Planning Stage Structural Report

150 Day Street

Prepared for UOL / 20th March 2025

Issue: Revision 2

1 L21 PLAN
RS_200 1:200

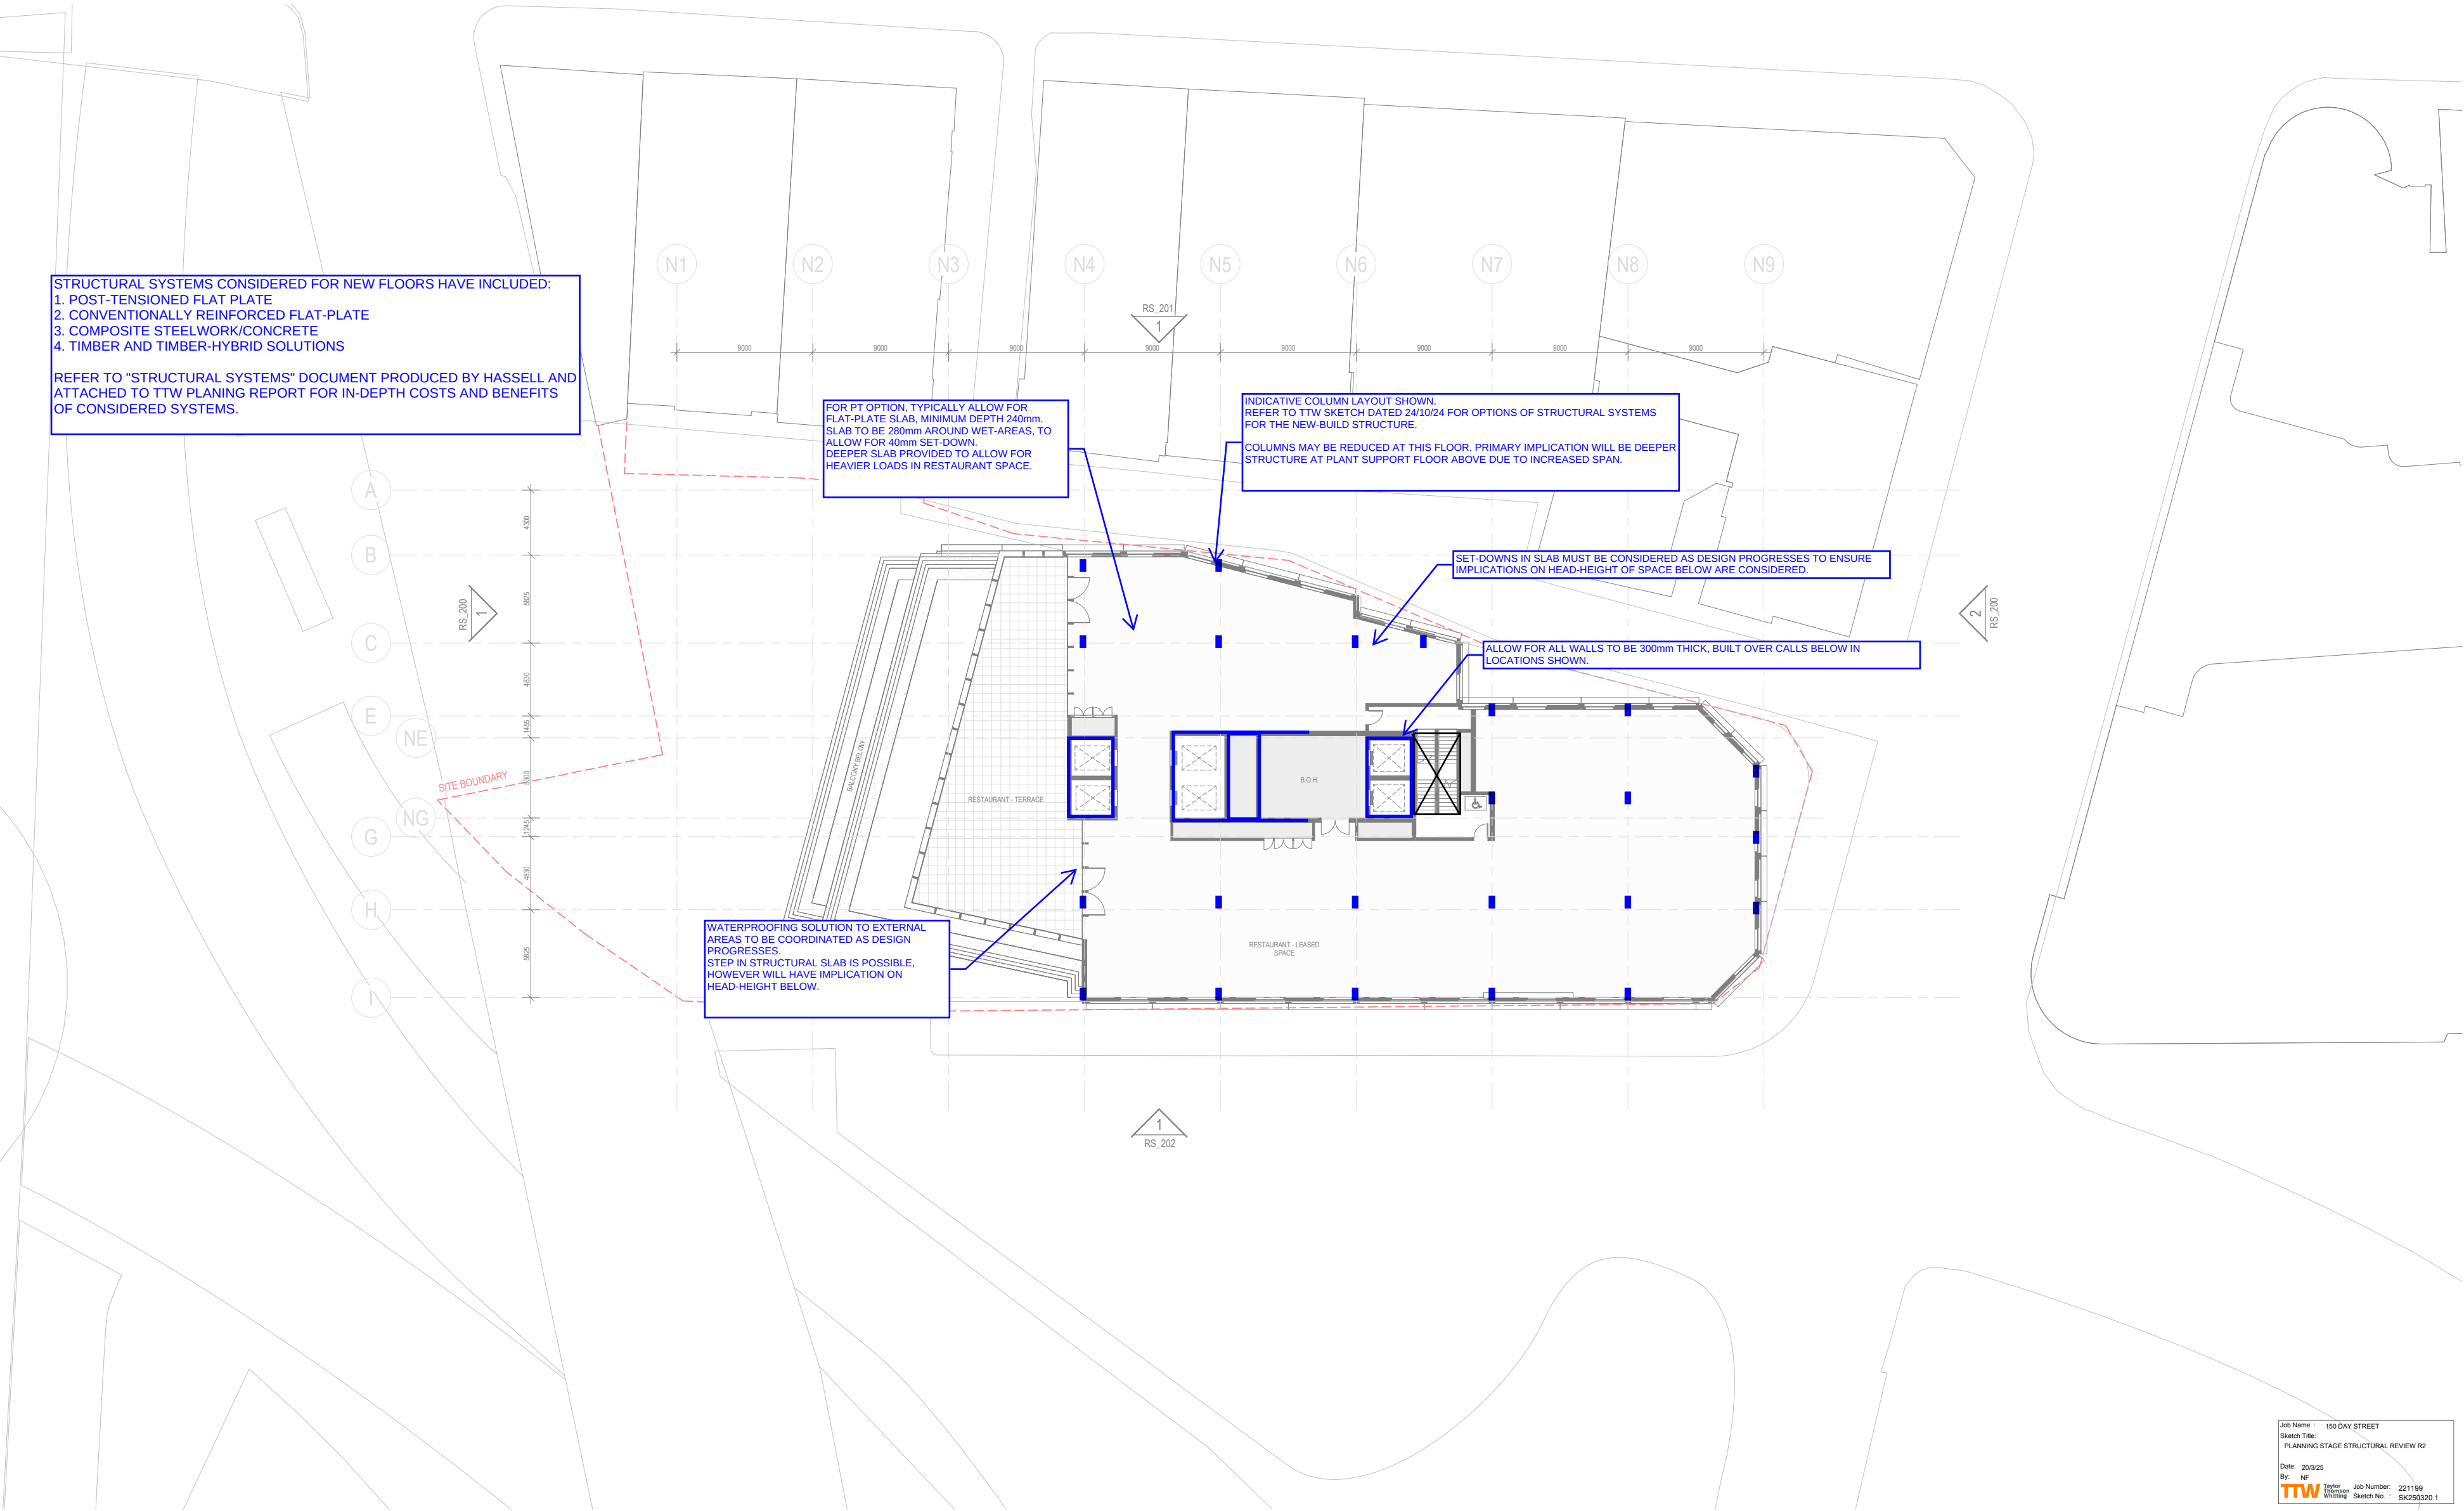
FOR PT OPTION, TYPICALLY ALLOW FOR FLAT-PLATE SLAB, MINIMUM DEPTH 240mm. SLAB TO BE 280mm AROUND WET-AREAS, TO ALLOW FOR 40mm SET-DOWN. DEEPER SLAB PROVIDED TO ALLOW FOR HEAVIER LOADS IN RESTAURANT SPACE.

INDICATIVE COLUMN LAYOUT SHOWN. REFER TO TTW SKETCH DATED 24/10/24 FOR OPTIONS OF STRUCTURAL SYSTEMS FOR THE NEW-BUILD STRUCTURE.

COLUMNS MAY BE REDUCED AT THIS FLOOR. PRIMARY IMPLICATION WILL BE DEEPER STRUCTURE AT PLANT SUPPORT FLOOR ABOVE DUE TO INCREASED SPAN.

1 L22 PLAN - PLANT
RS_200 1:200

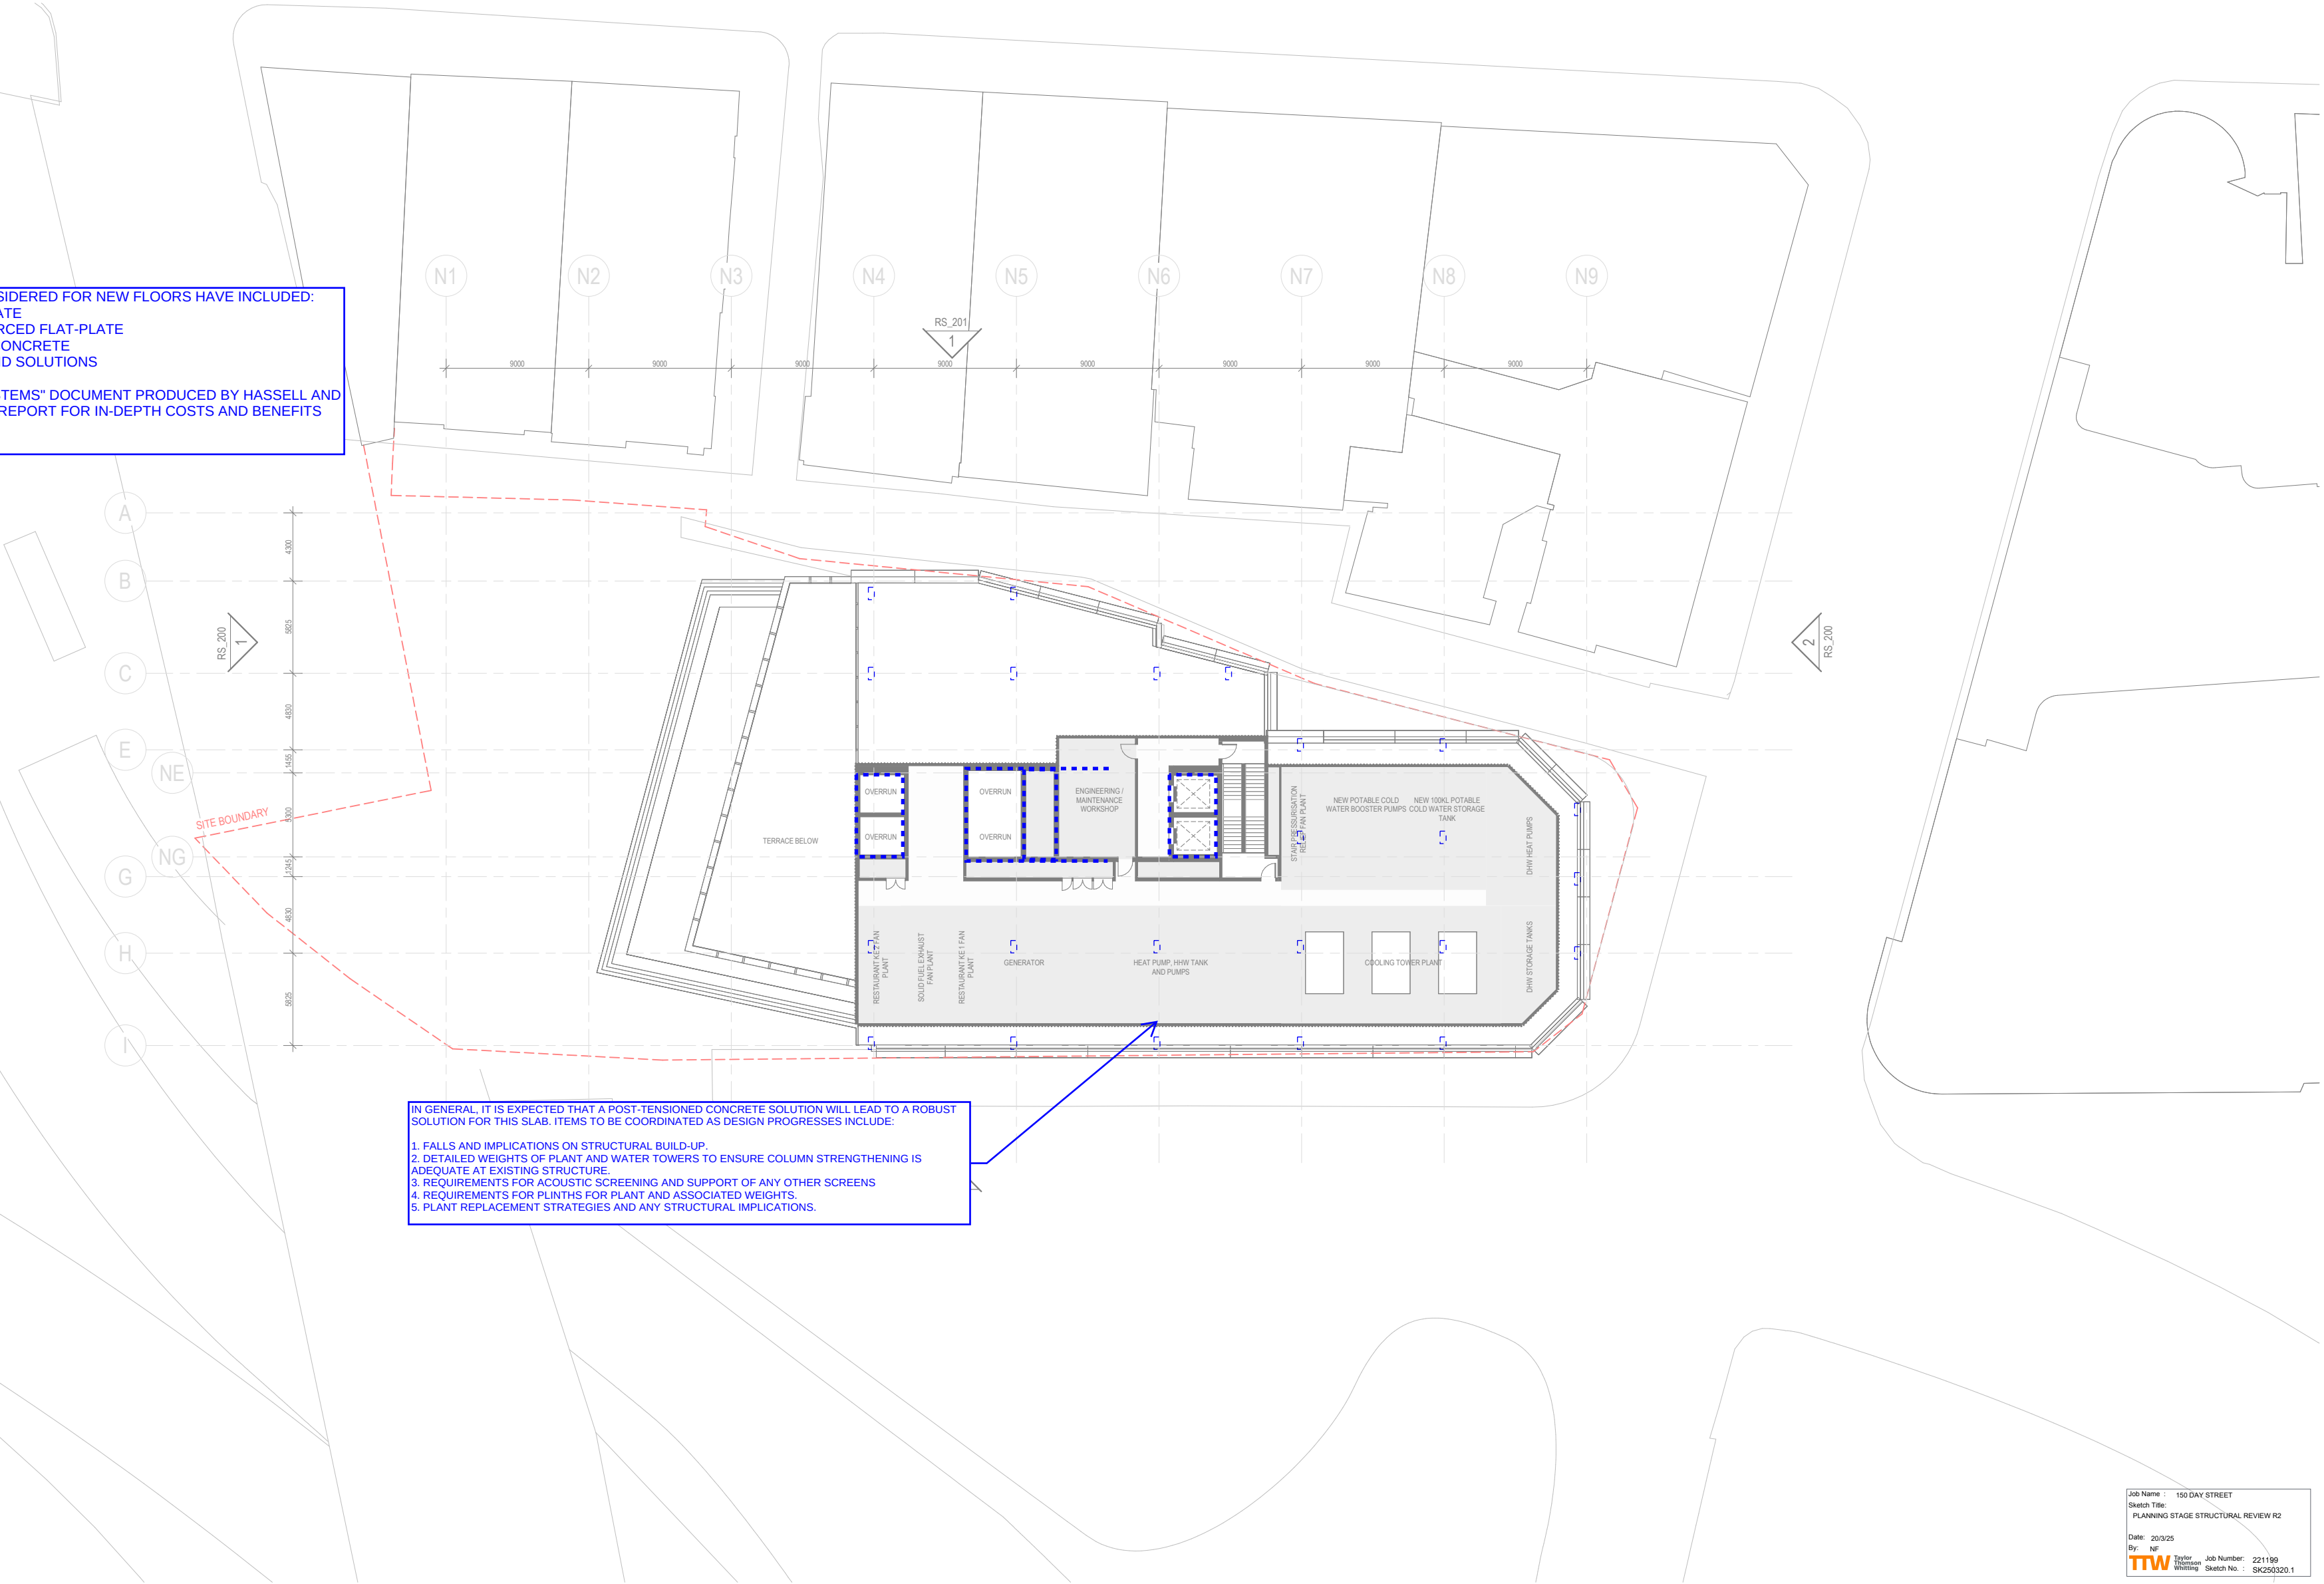
1. FALLS AND IMPLICATIONS ON STRUCTURAL BUILD-UP.
2. DETAILED WEIGHTS OF PLANT AND WATER TOWERS TO ENSURE COLUMN STRENGTHENING IS ADEQUATE AT EXISTING STRUCTURE.
3. REQUIREMENTS FOR ACOUSTIC SCREENING AND SUPPORT OF ANY OTHER SCREENS
4. REQUIREMENTS FOR PLINTHS FOR PLANT AND ASSOCIATED WEIGHTS.
5. PLANT REPLACEMENT STRATEGIES AND ANY STRUCTURAL IMPLICATIONS.
